**Proposed Development  
SOPA Site,  
Wentworth Point.**

**Transport Impact Study  
Addendum**

September 2014

Job title:	SOPA Site Transport	Job number
		2013119

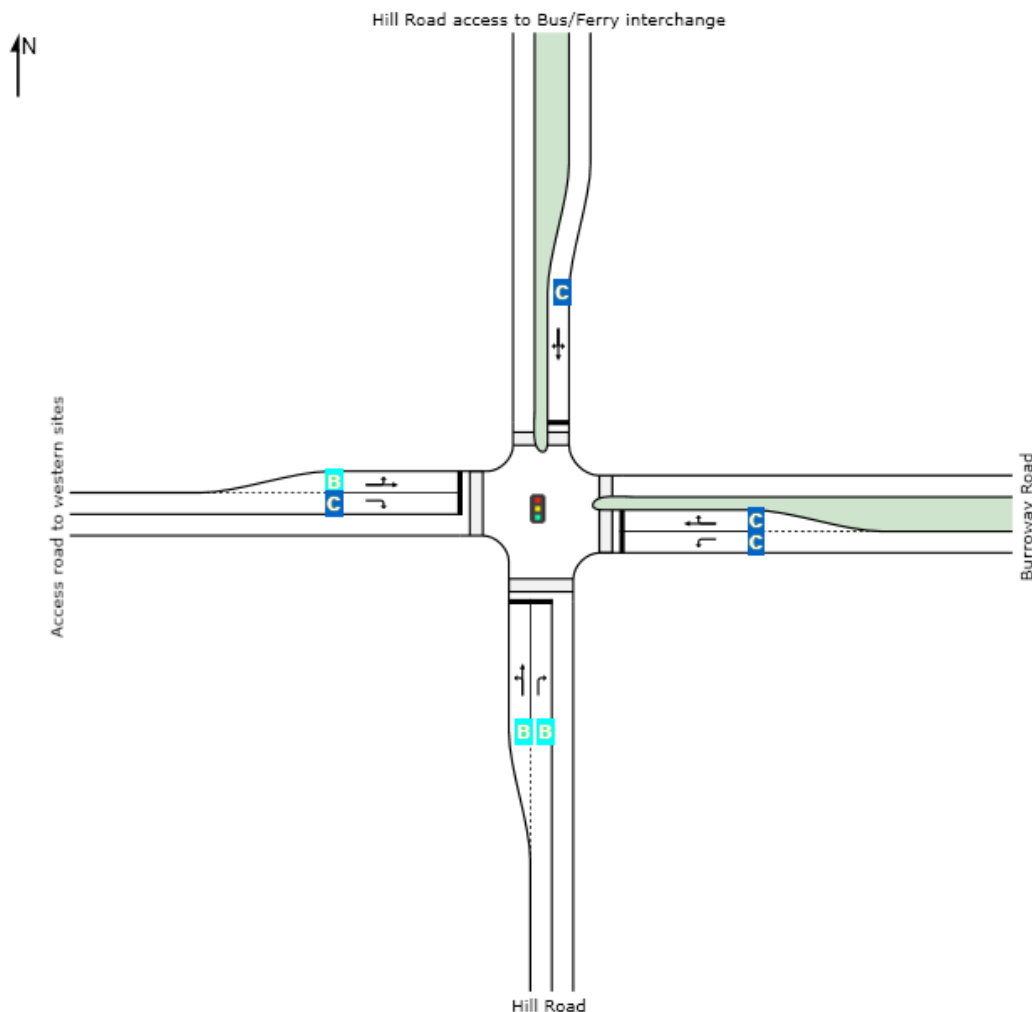
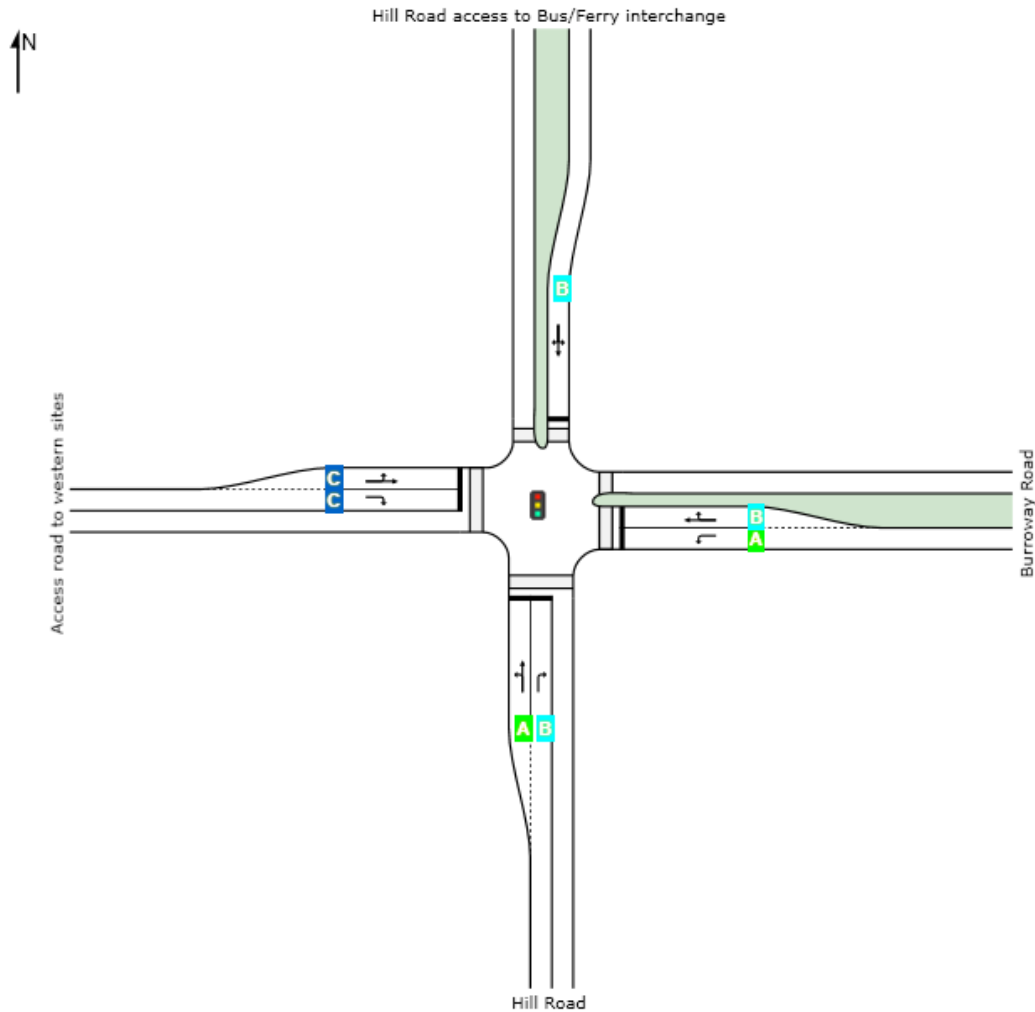
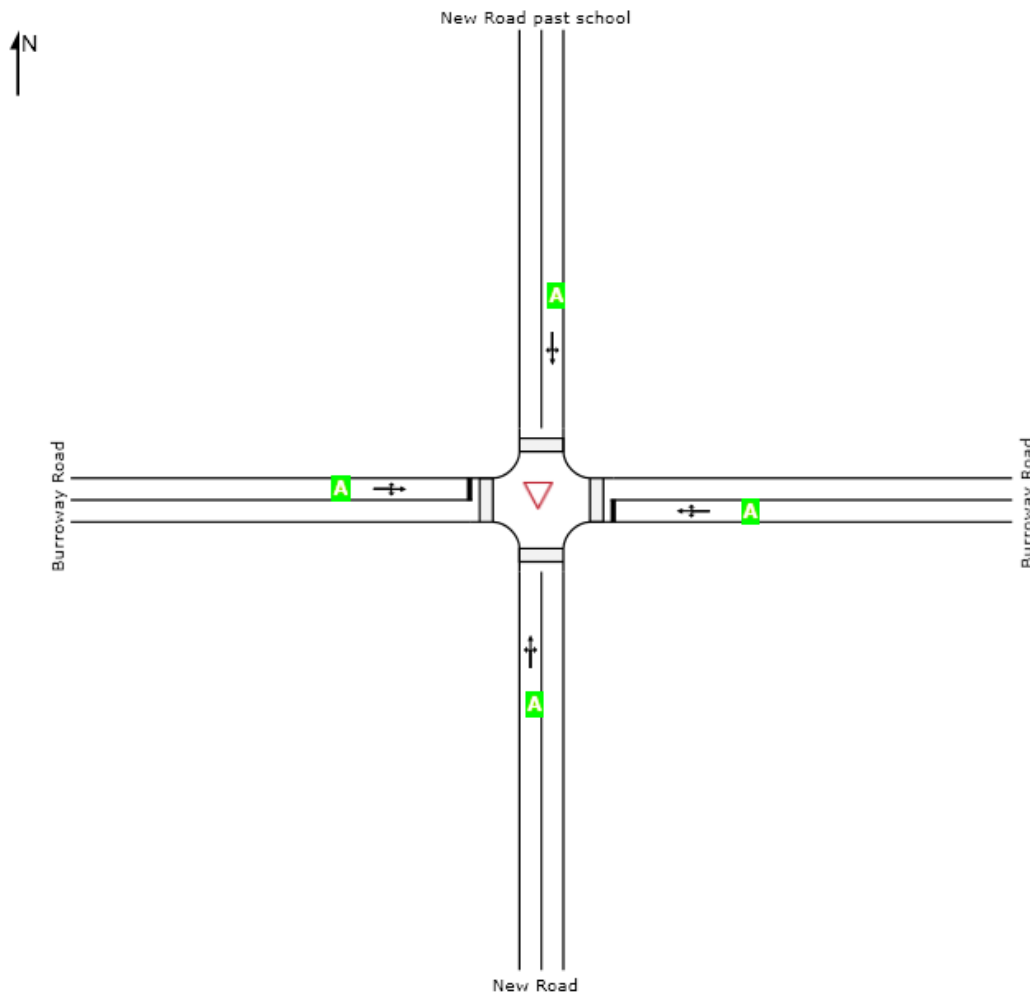
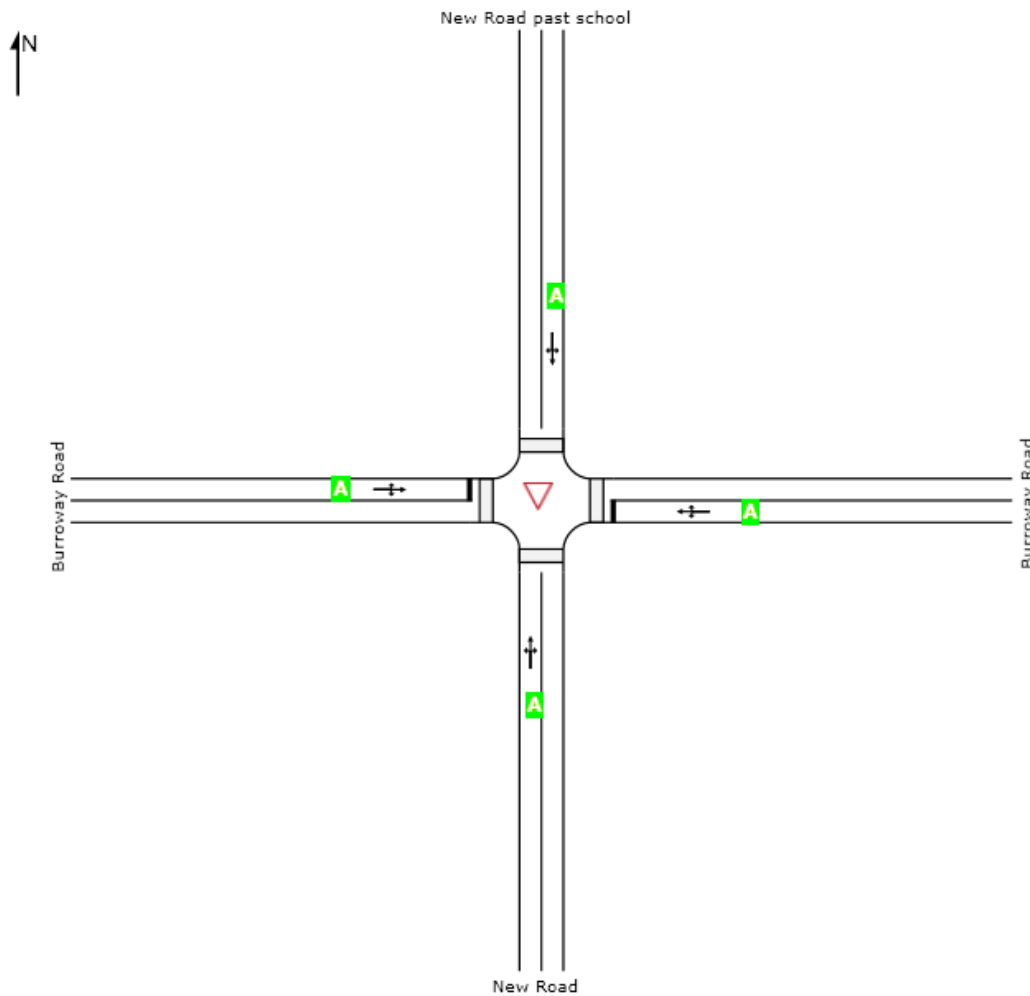
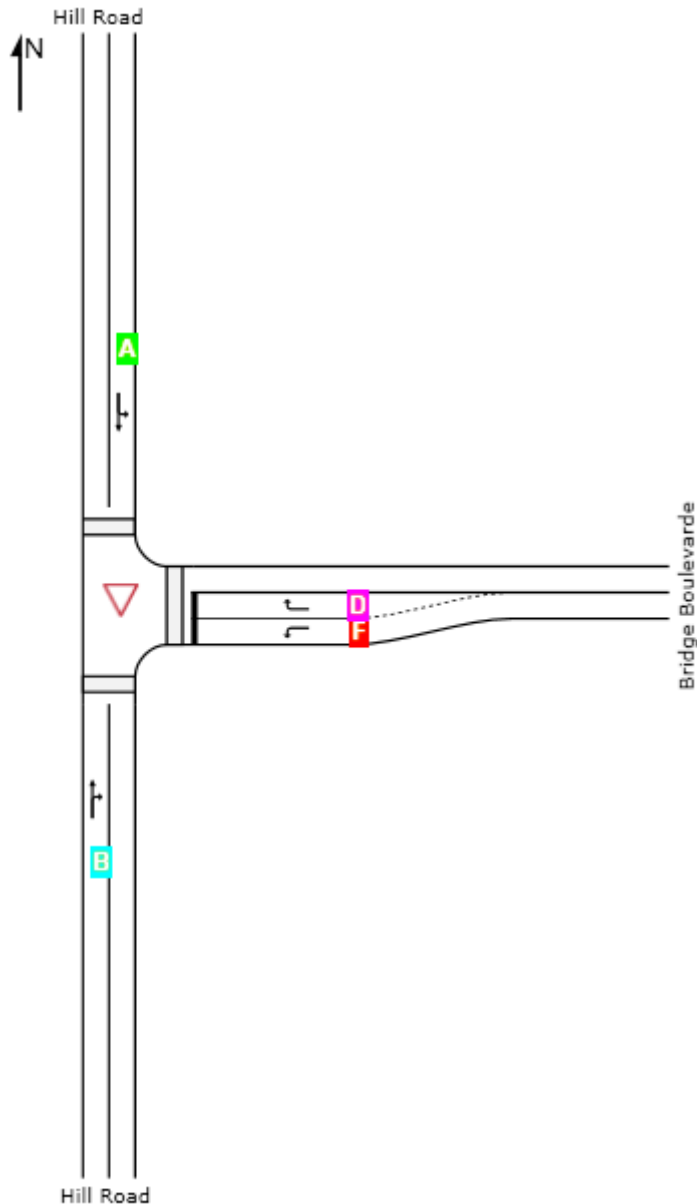
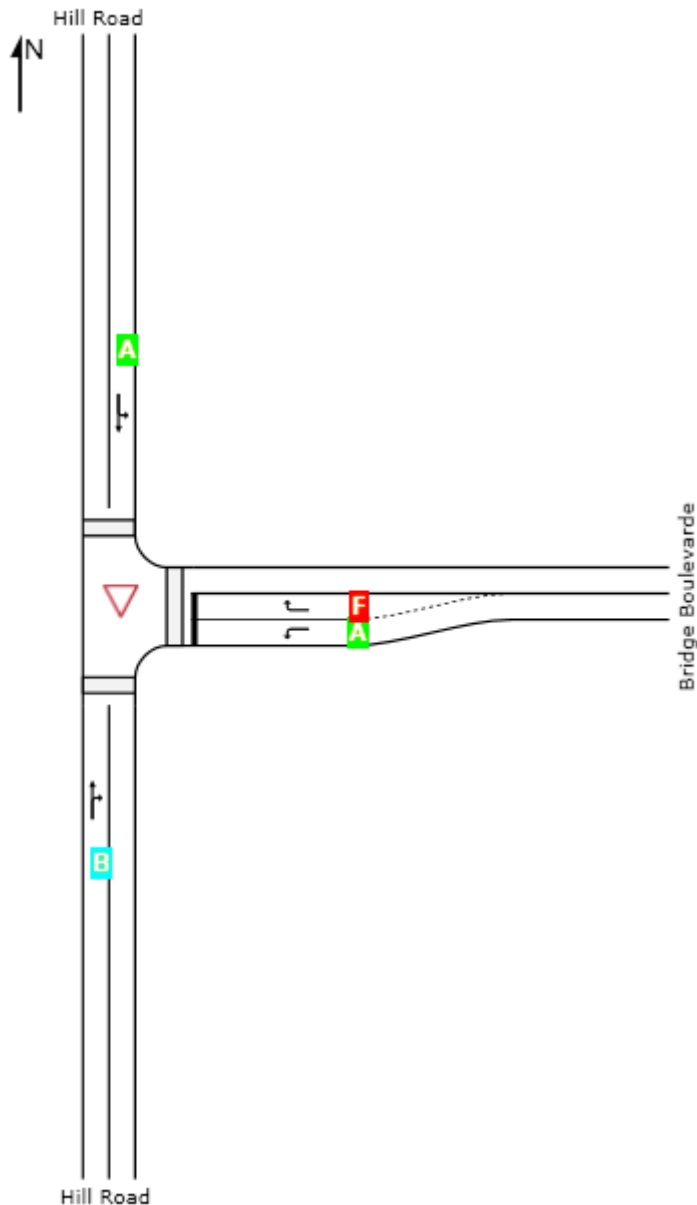
**6.10 Intersection of Burroway Road and New Road There is insufficient information to determine whether the intersection of Burroway Road and New Road will operate adequately to ensure safe and efficient operation, given likely future pedestrian and traffic generation from the site, as well as potential traffic from the adjoining school site. • The SIDRA modelling results for the PM peak for this intersection do not appear to be included in the traffic assessment, which is necessary for TfNSW to undertake a comprehensive assessment on public transport and vehicle impacts.**

Full SIDRA analysis included in the Appendix

SIDRA diagrams are provided in the Appendix.

### Site: Hill Road/Burroway Road (signals) Future Special Event

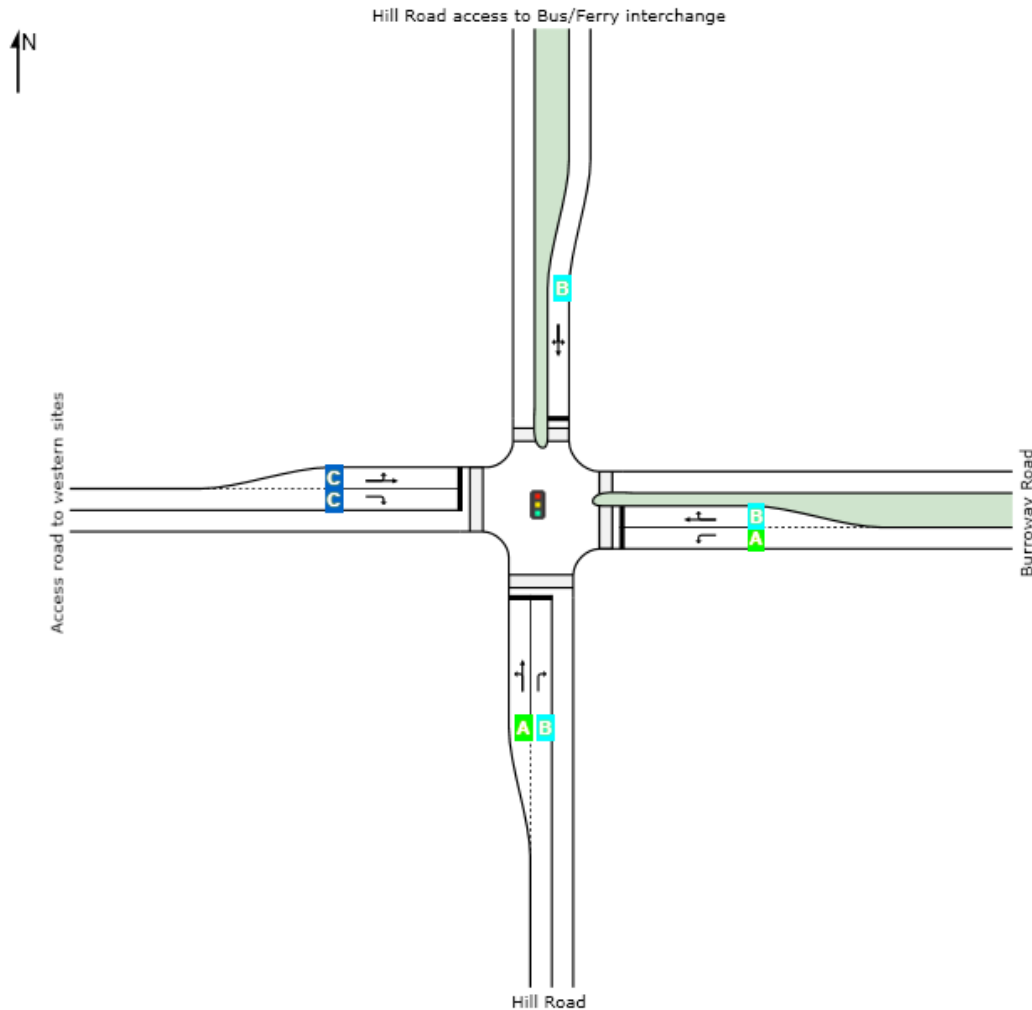
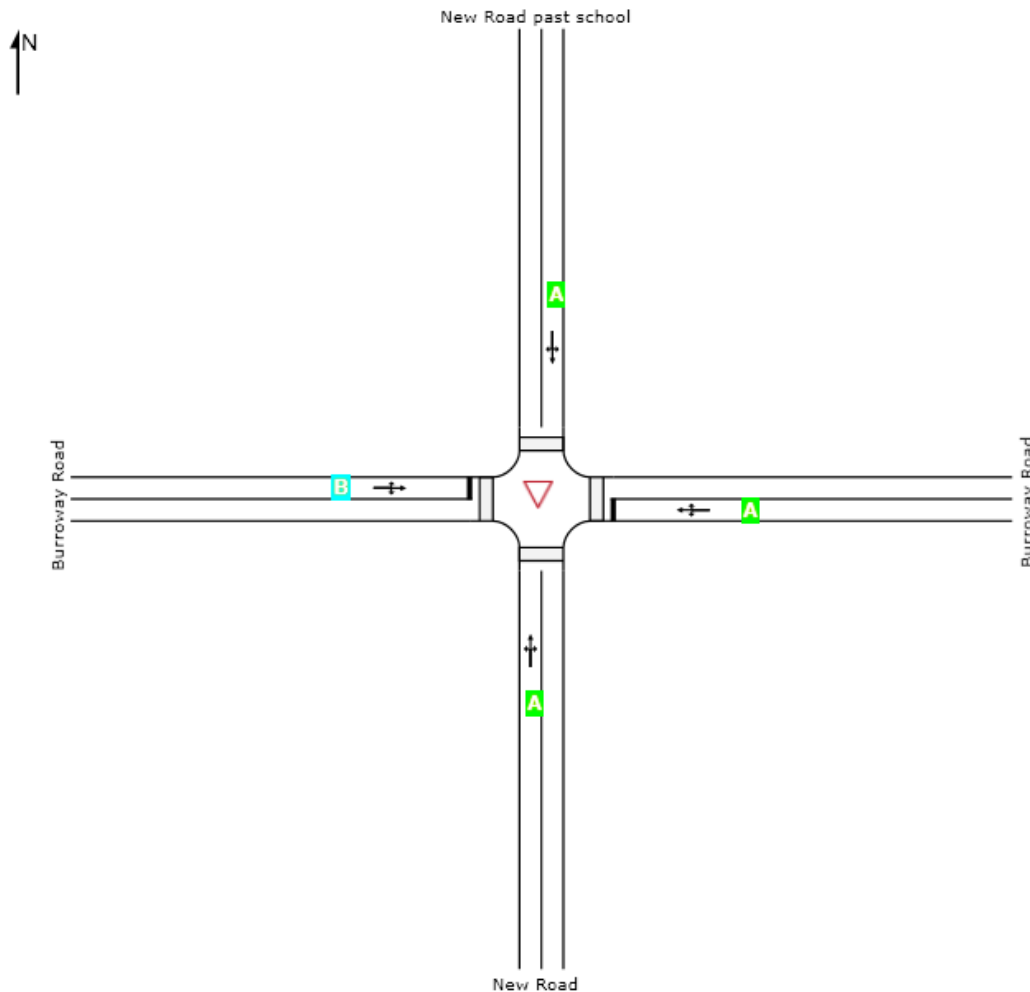
**6.9 Intersection of Burroway Road and Hill Road. TfNSW has concerns the future intersection, as proposed in the Wentworth Point UAP Traffic Impact Assessment will not be able to support safe and efficient transport movements with the changes to the existing interchange configuration plus the additional traffic generated by the proposed development. • It appears the design of the intersection approved under the Wentworth Point UAP was based on modelling which does not include the forecasted traffic generation from the additional 1,300 dwellings allowed under the now finalised Homebush Bay West Development Control Plan Amendment No.1. • TfNSW is concerned buses may block this intersection, especially during Special Events. During Special Events, up to 50 buses per hour will use this intersection to drop off and then pick up passengers. It is estimated up to 20 buses per hour could layover. o Provide SIDRA documentation demonstrating the proposed intersection's queue lengths are able to accommodate turning movements of at least two 14.5m buses. • Demonstrate the proposed intersection of Burroway Road and Hill Road will be able to safely and efficiently cater for all vehicular and pedestrian traffic with the approved and proposed development.**

**6.11 TfNSW is concerned buses may block this intersection, especially during Special Events. During Special Events, up to 50 buses per hour will use this intersection to drop off and then pick up passengers. It is estimated up to 20**

**buses per hour could layover. o Provide SIDRA documentation demonstrating the proposed intersection's queue lengths are able to accommodate turning movements of at least two 14.5m buses. • Demonstrate the proposed intersection of Burroway Road and New Road will be able to safely and efficiently process all vehicular and pedestrian traffic with the approved and proposed development.**

A separate SIDRA analysis of a Special Event as described by TfNSW was applied to the key junctions, and is presented at the end of the Appendices. 50 buses per hour were added to the key movements shown as follows:

All of these key bus movements still operated at LOS A with the 50 extra buses added to the everyday traffic and parking, even without Special Event management.

It is therefore concluded that the proposed road network can accommodate Special Events.
